## ADDENDUM NO. 1

TO: ALL BIDDERS OF RECORD  
PROJECT: Redwater River Fish Passage

FWP PROJECT #: 7163601

DATE: 06/20/2016

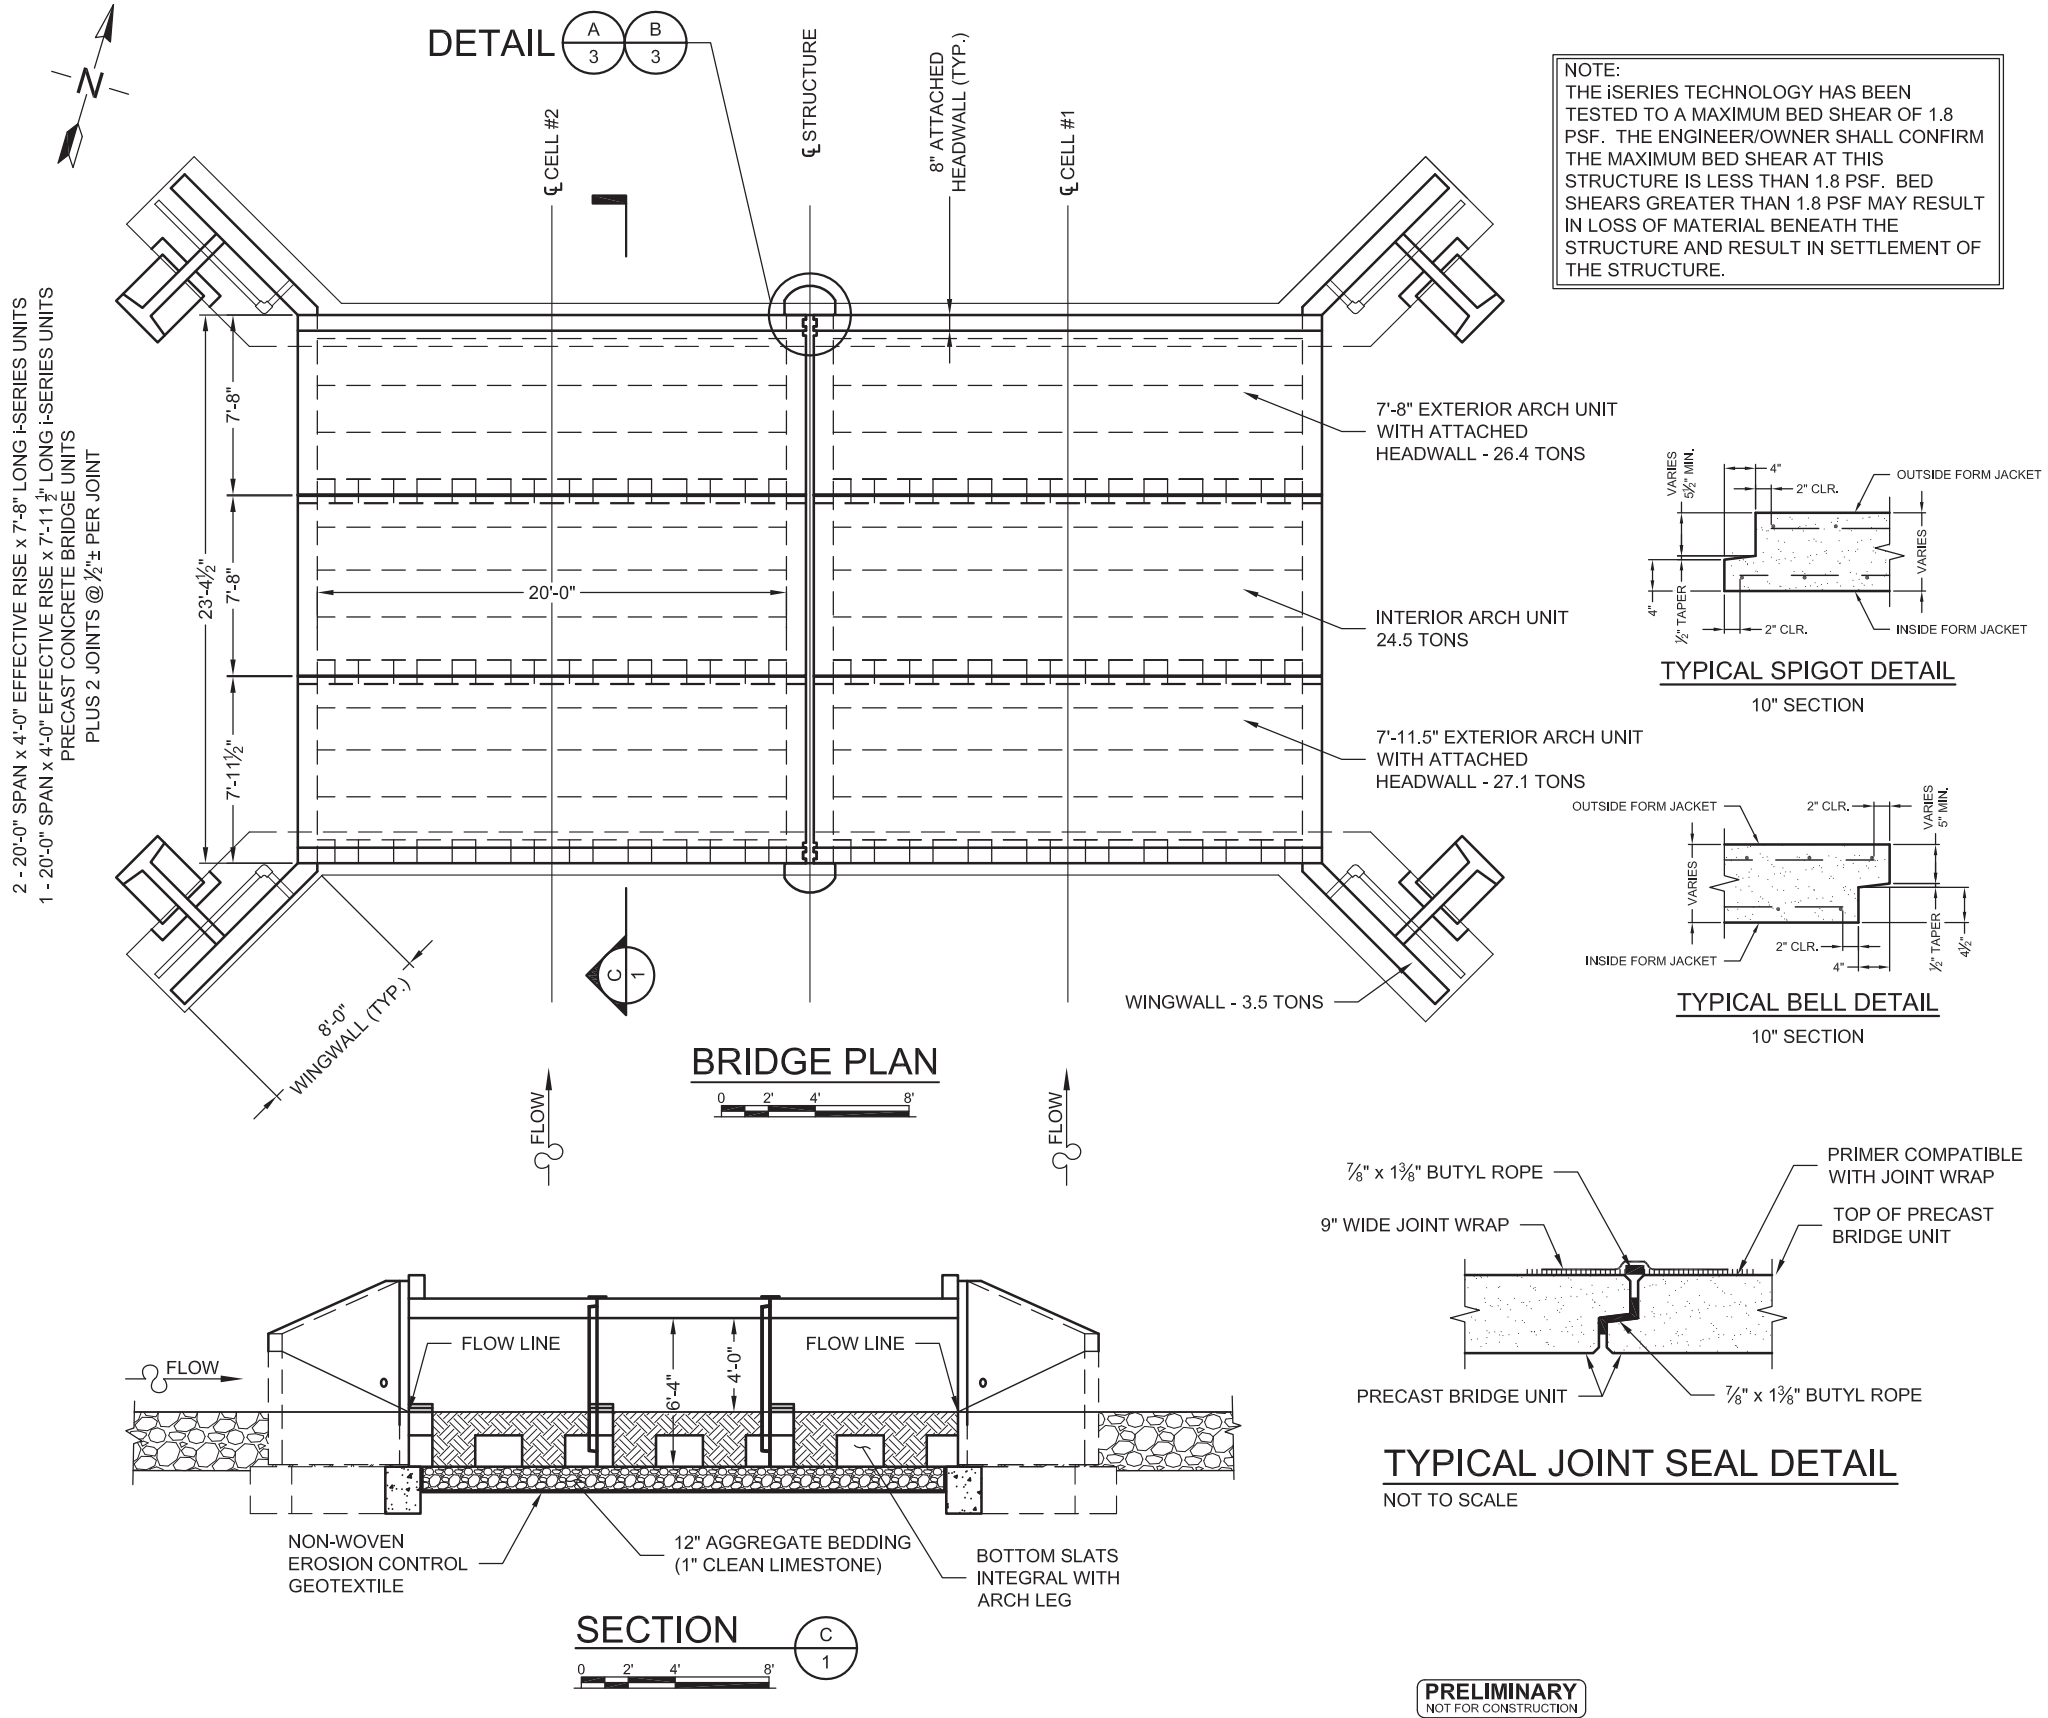
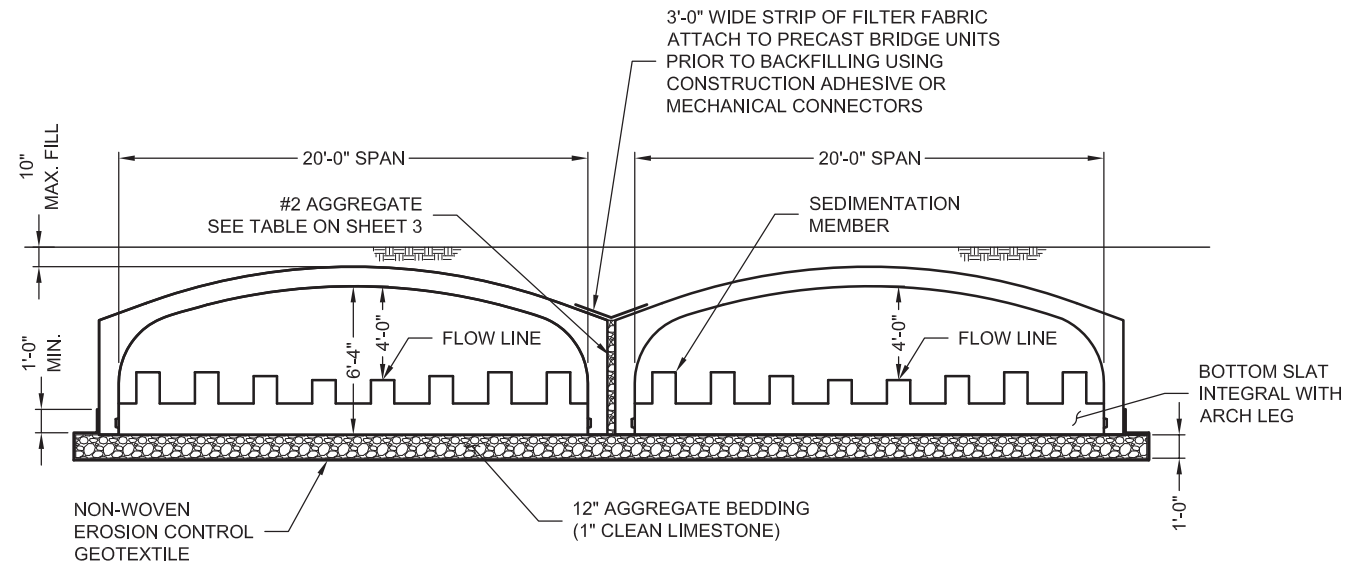
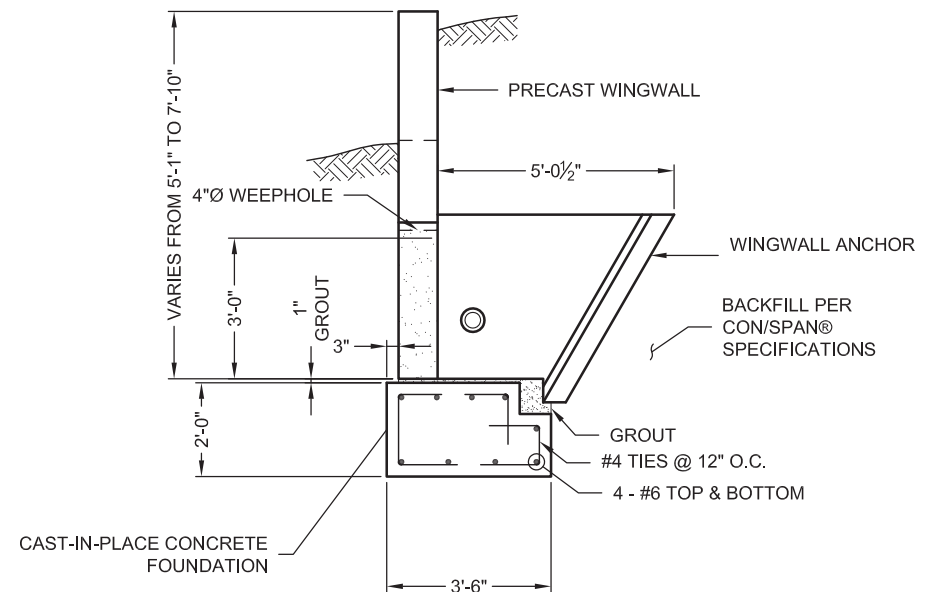
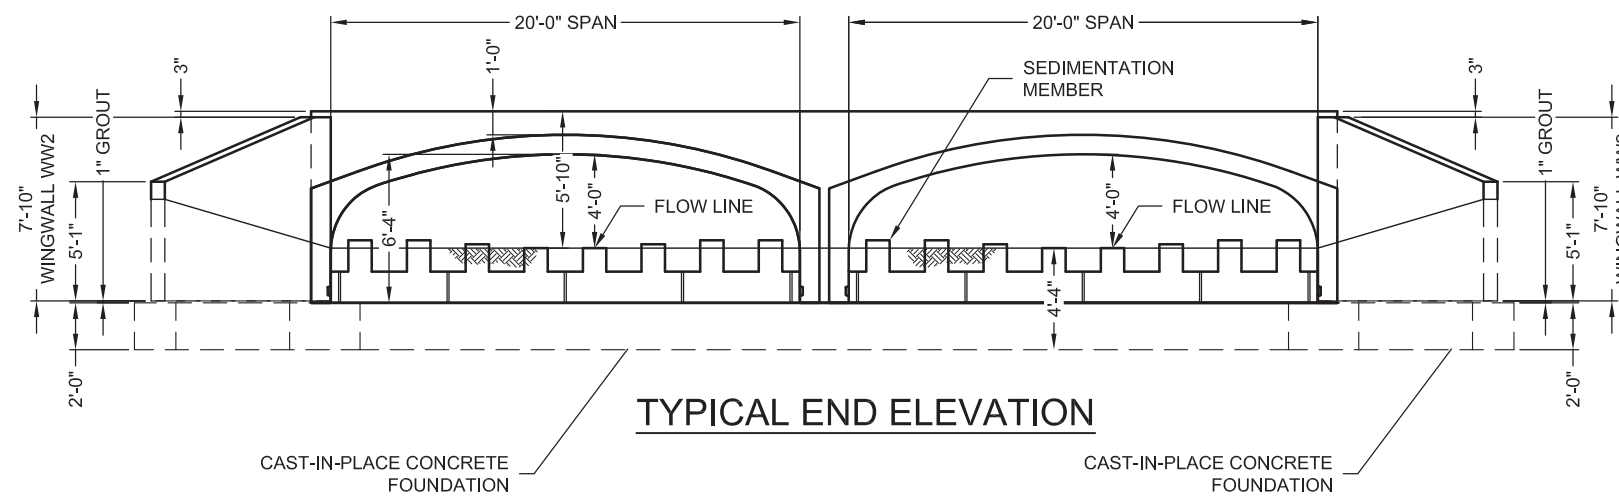
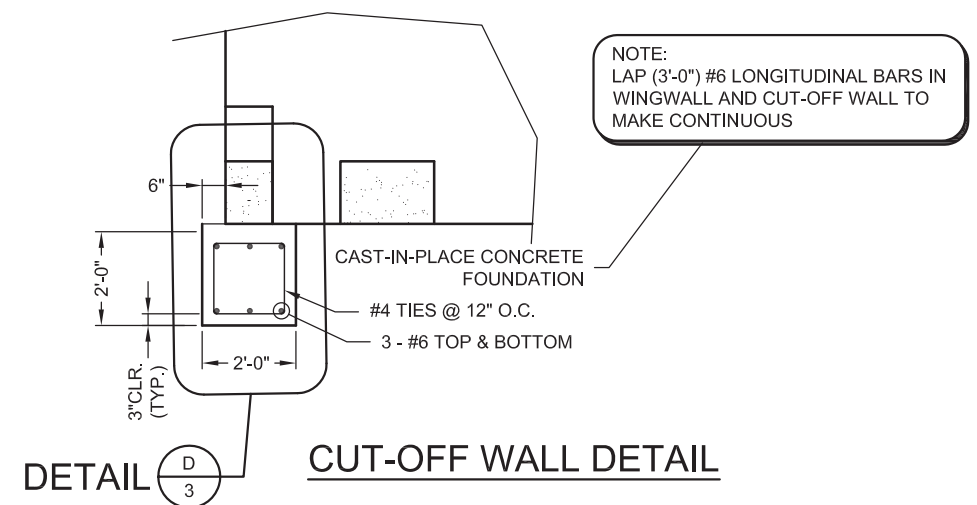
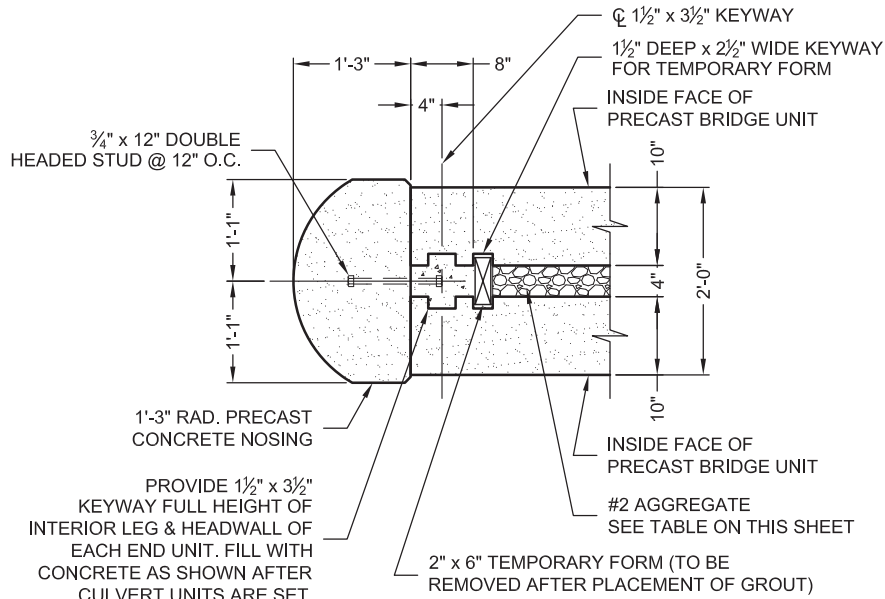
1. Modification – **Contech i-Series Design Drawings:**  
Disregard all existing Contech drawings and replace with the attached 5 sheets. Additional details and information have been added to the new sheets. Weights of each section are now shown on sheet 1 of 5. All questions regarding the new Contech plans can be directed to Tim Miller, [tmiller@conteches.com](mailto:tmiller@conteches.com) or by phone at 307-631-5761.

Poplar, MT to Redwater River

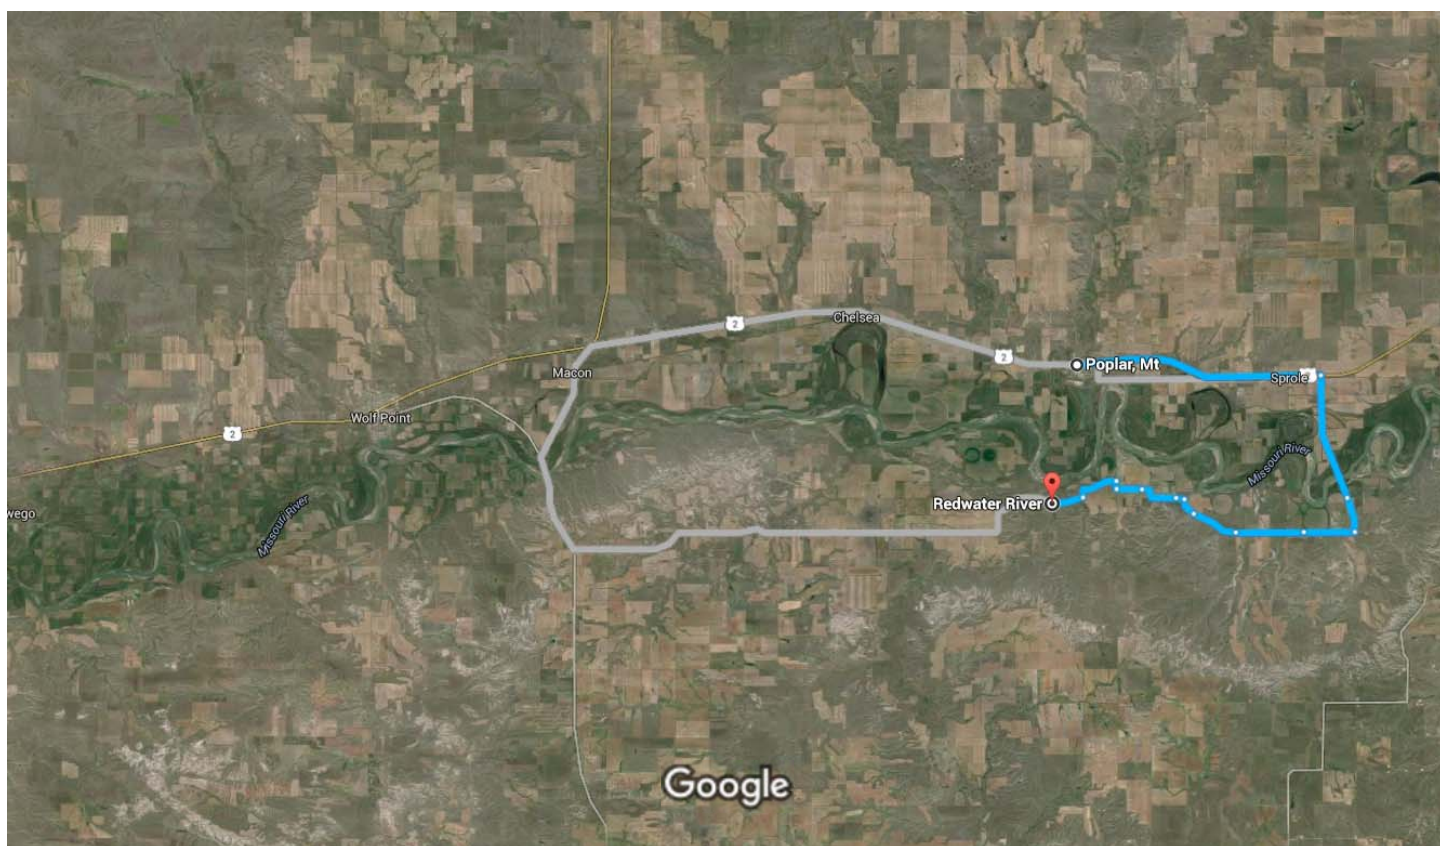
2. Clarification – During the pre-bid meeting, a country road bridge located on Nickwall Road was noticed to have a load rating of 11 tons. It is the responsibility of the contractor to have the bridge analyzed by a professional engineer if the contractor chooses to bring loads exceeding 11 tons across the bridge. All costs associated with the analysis and any necessary improvements to the bridge, will be the responsibility of the contractor. There is an alternative route to the project site that does not have any limiting bridges. A map showing this route is attached with this addendum.
